**Amendments to the Drawings:**

The enclosed Submission of Formal Drawings includes changes to Figs. 14A-14E, 14H-14P, 15A, 16A, 16B, 16D, 16F, 17P-17CC (now Figs. 17O-17BB), 18B (now Fig. 18B-4), 18C, 18H, 19H, 33D and 64B.

Attachment: Annotated Sheet Showing Changes

Fig 14 A

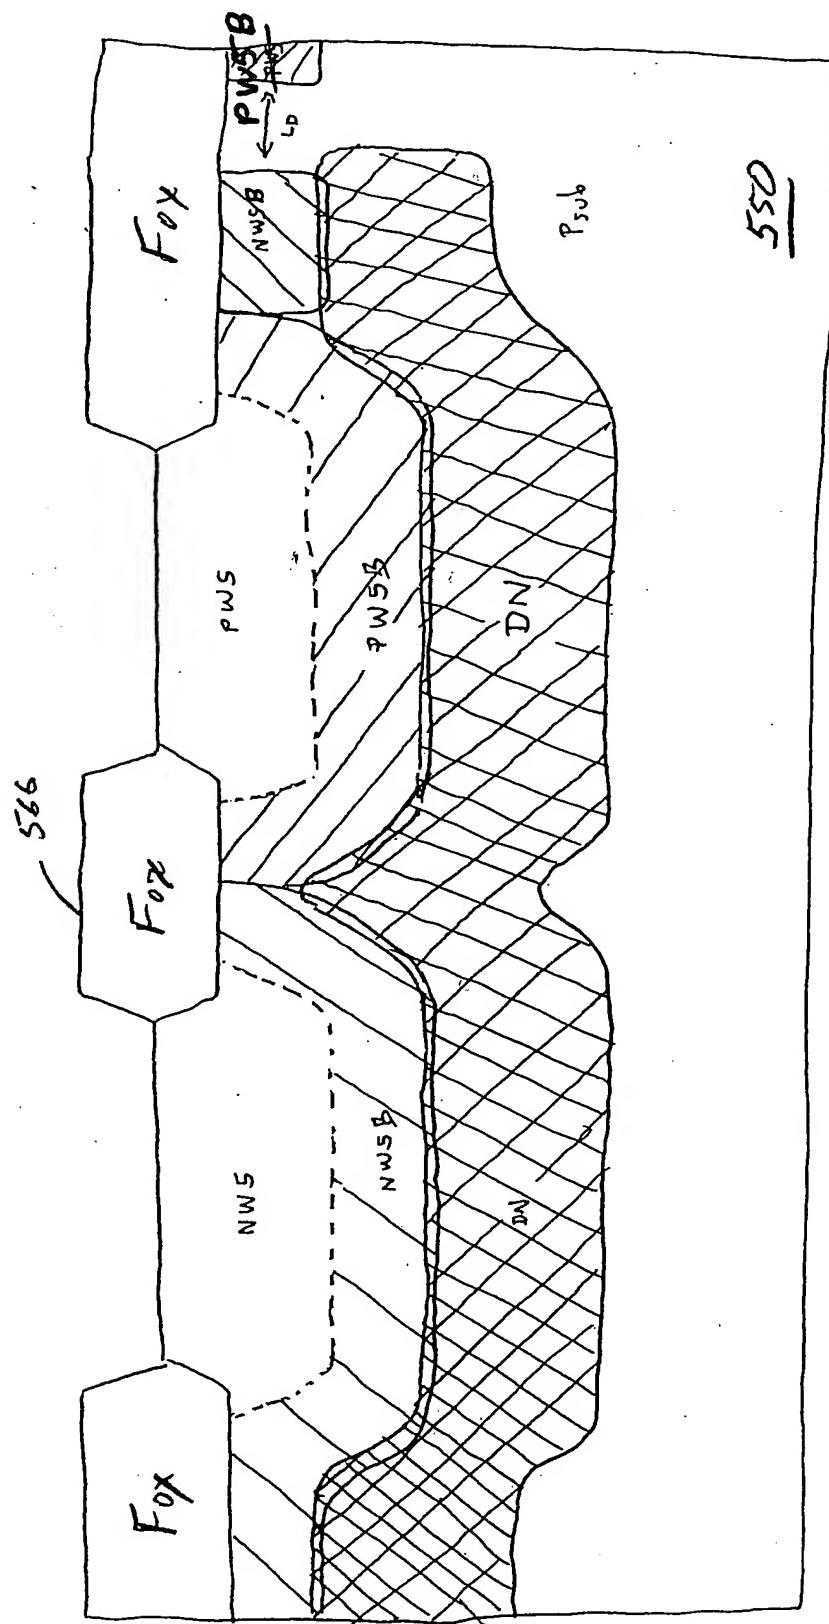
In Figs. 14A-14E, 14H-14P, 15A, 16A, 16B, 16D and 16F, in a number of instances the reference numeral PW5 has been changed to PW5B, the reference numeral NW5 has been changed to NW5B, the reference numeral PW12 has been changed to PW12B, and the reference numeral NW12 has been changed to NW12B, as shown on the enclosed Annotated Sheets. These changes are clearly supported, for example, at page 36, lines 14-17, of the substitute specification filed February 18, 2004, where it is indicated that the suffix "B" is used to denote an implanted layer of dopant as opposed to a "well" of dopant. In any event, these changes are merely changes in labeling and as such do not constitute new matter.

Fig. 18C

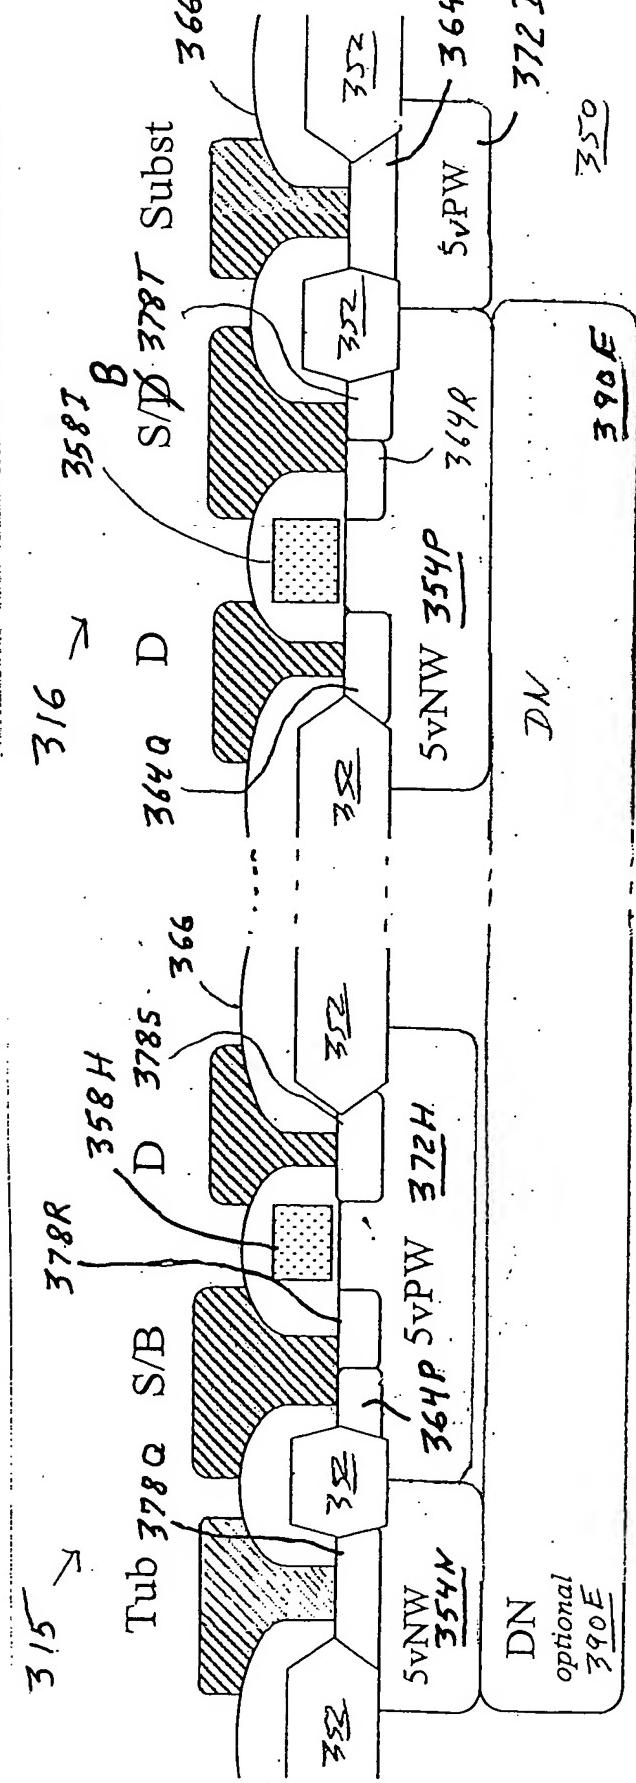
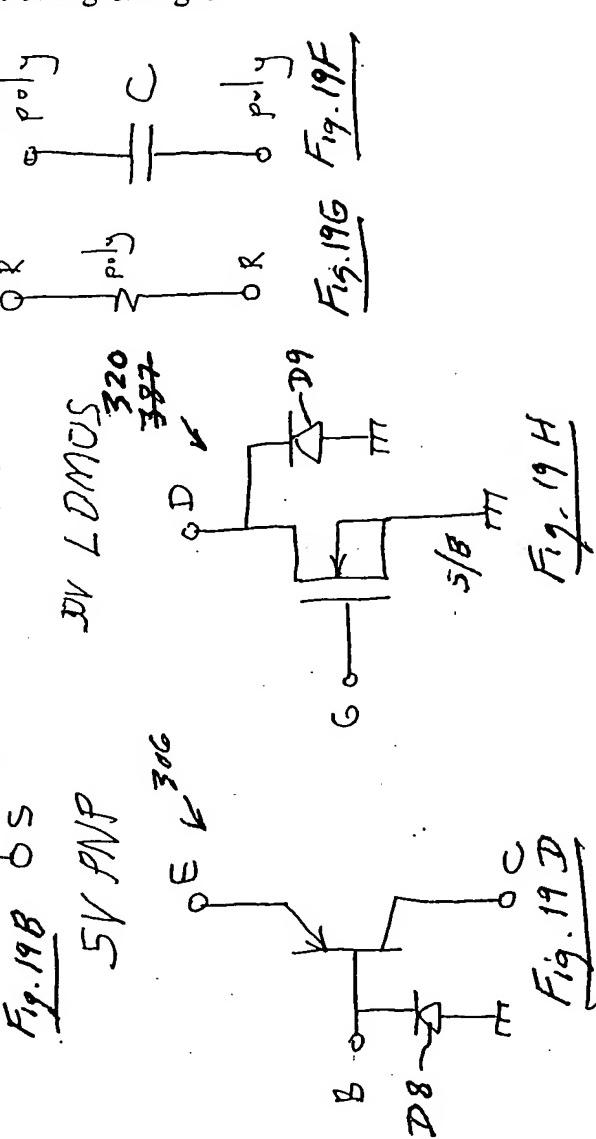
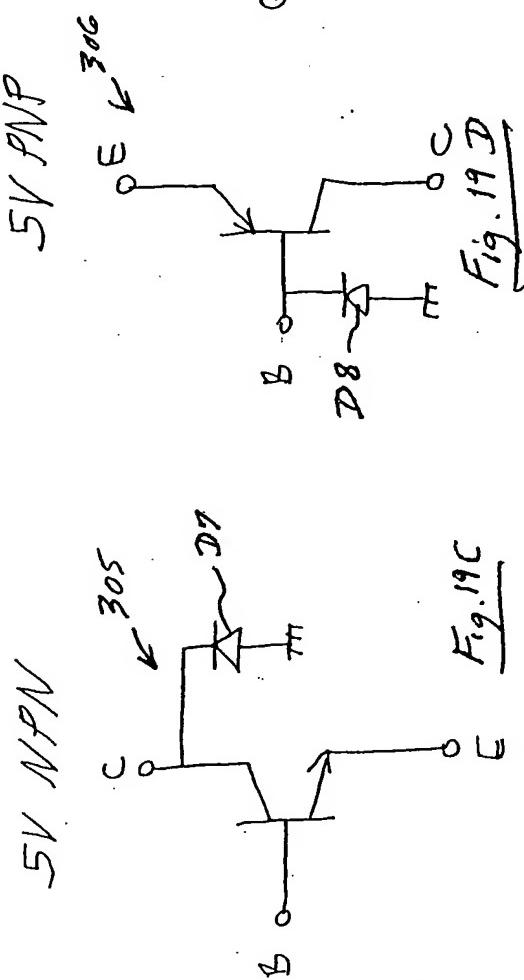
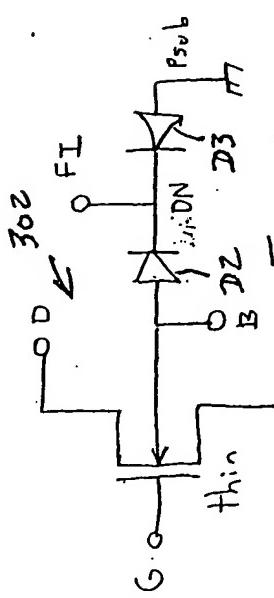
In Fig. 18C, the reference numeral 364P, which is referred to at page 66, line 4, of the substitute specification, has been added, and the designation of the source-body contact has been corrected from "S/D" to "S/B".

Interlayer Dielectric  
Fig 33D

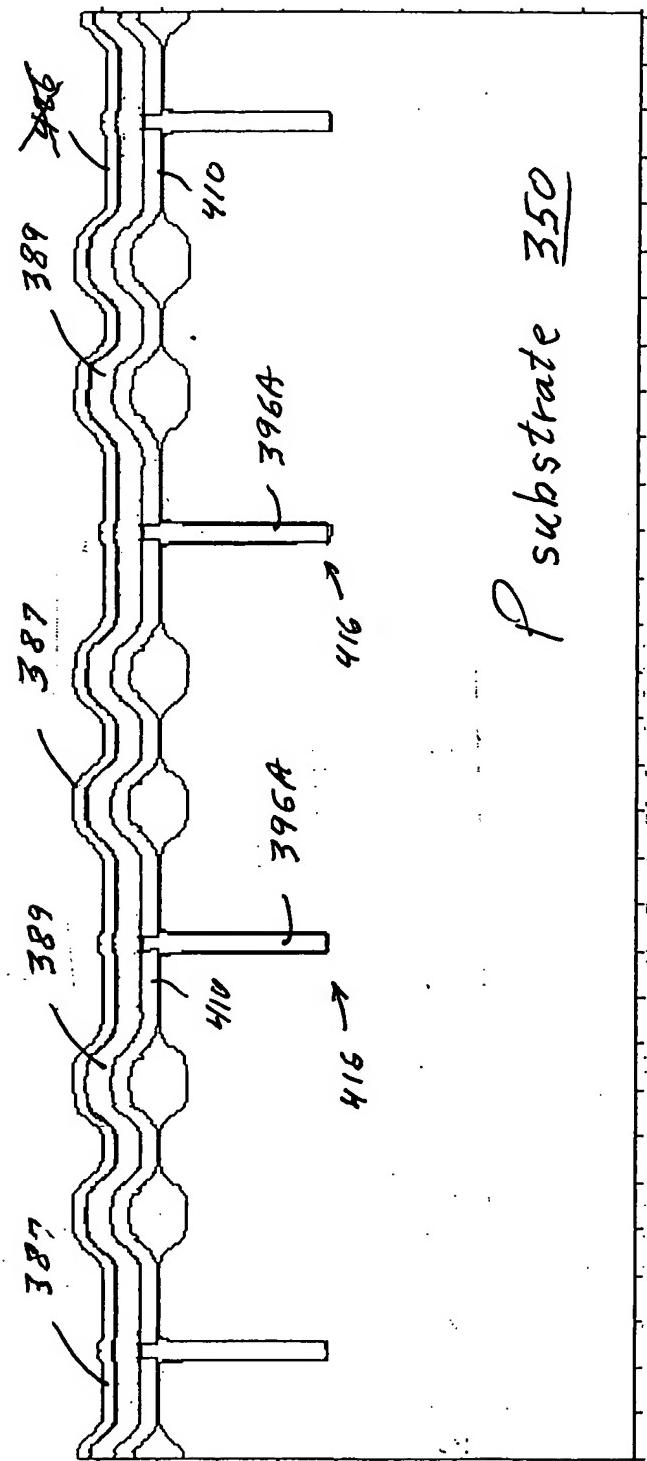
In Fig. 33D, the reference numeral 486 has been deleted. It is not referenced in the specification.

Fig. 64B

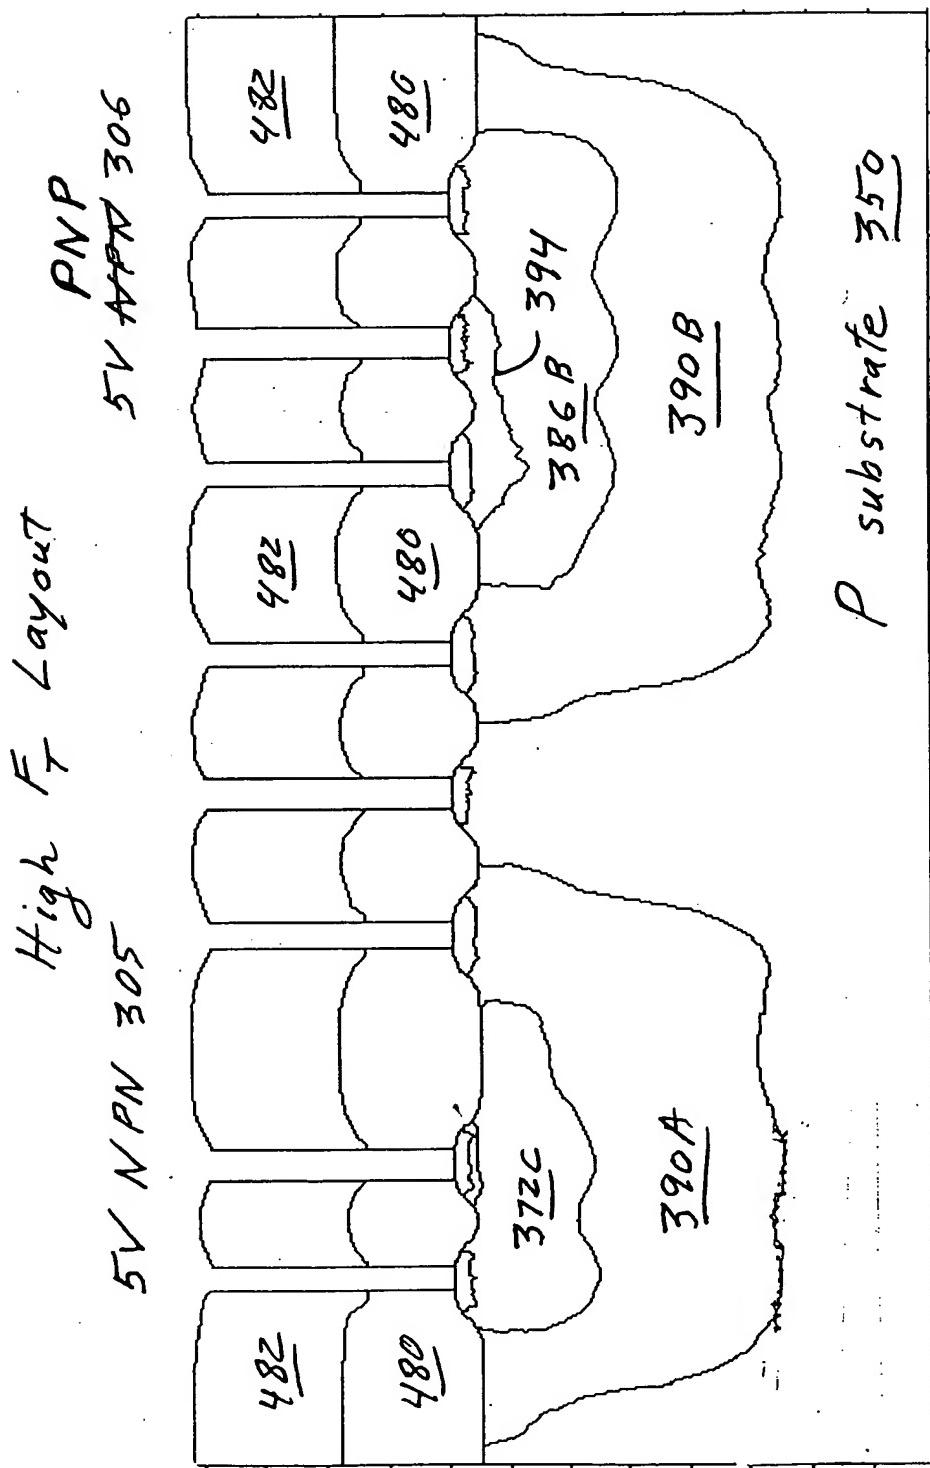
In Fig. 64B, the description of the 5 volt transistor 306 as been corrected to "PNP."

Fig. 17~~X~~<sup>U</sup>

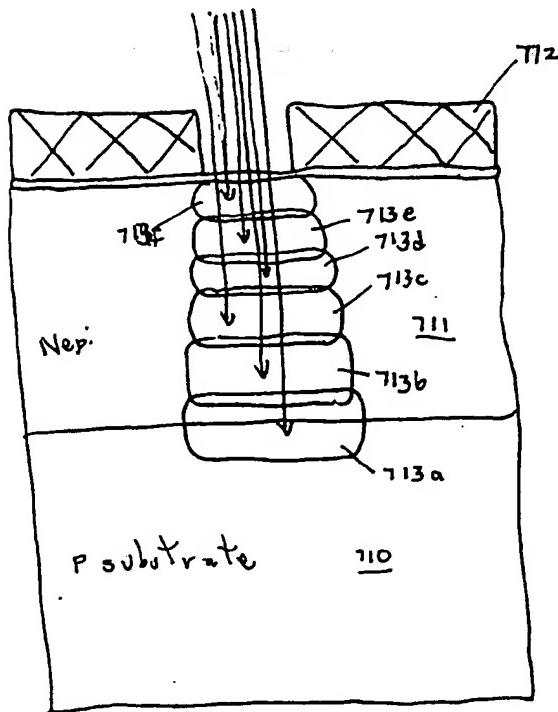
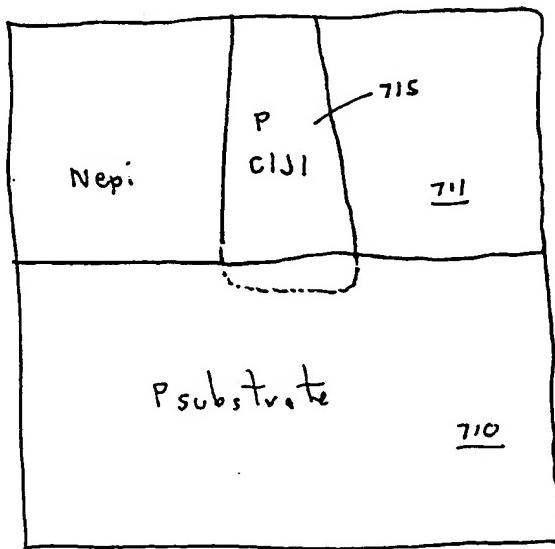
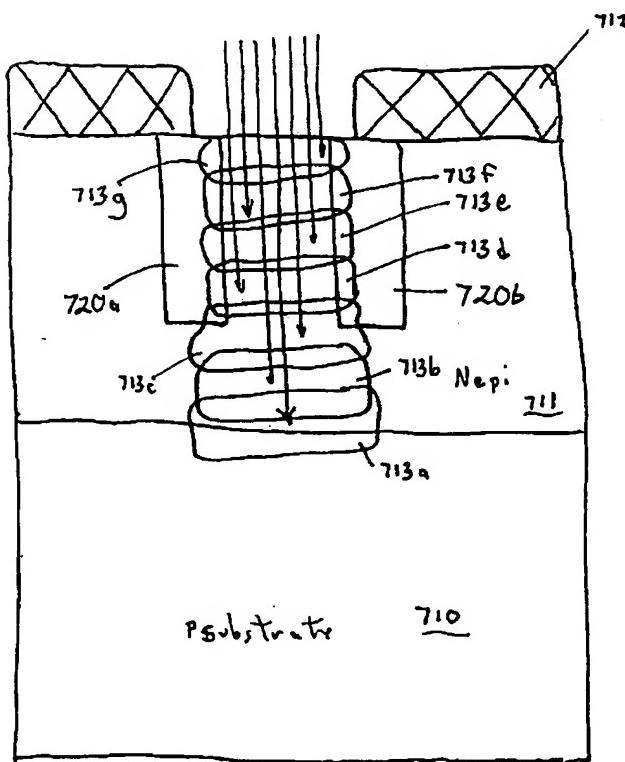
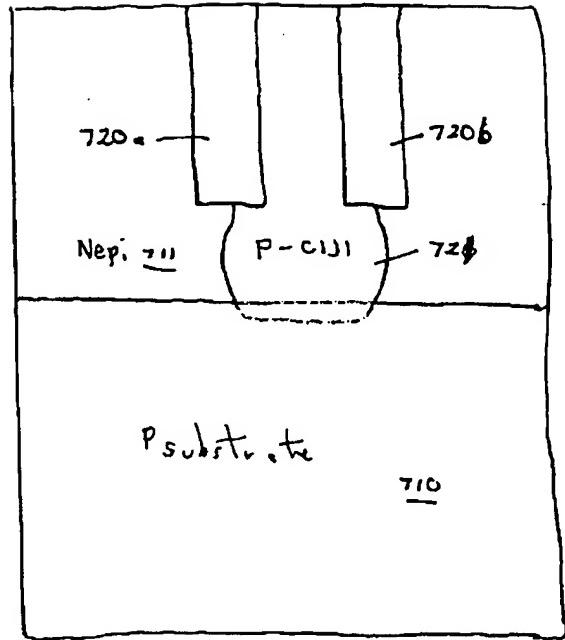
Figs. 17P-17CC have been renumbered as Figs. 17O-17BB, respectively, to rectify the omission of Fig. 17O from the application as filed.

Fig. 18 H

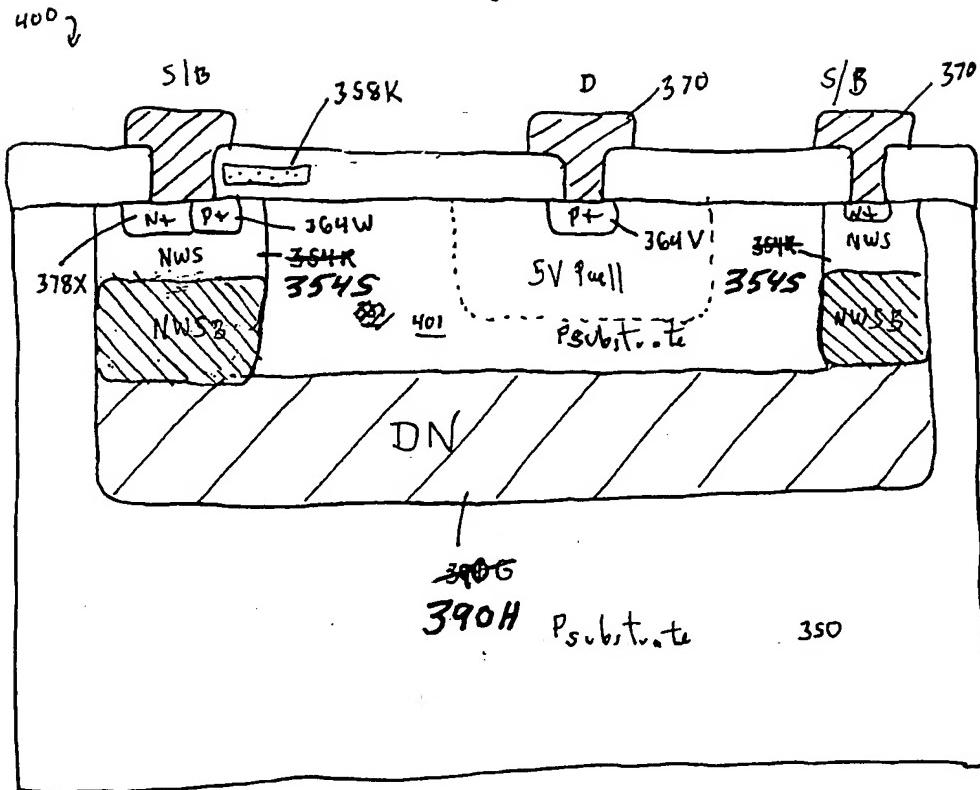
In Fig. 18H, the reference numeral applicable to the well NW5 has been changed from 354R to 354S to eliminate the conflict with the similarly numbered element in Fig.

18G; and the reference numeral applicable to the deep N layer has been changed from 390G to 390H to eliminate the conflict with the similarly numbered element in Fig. 35A.
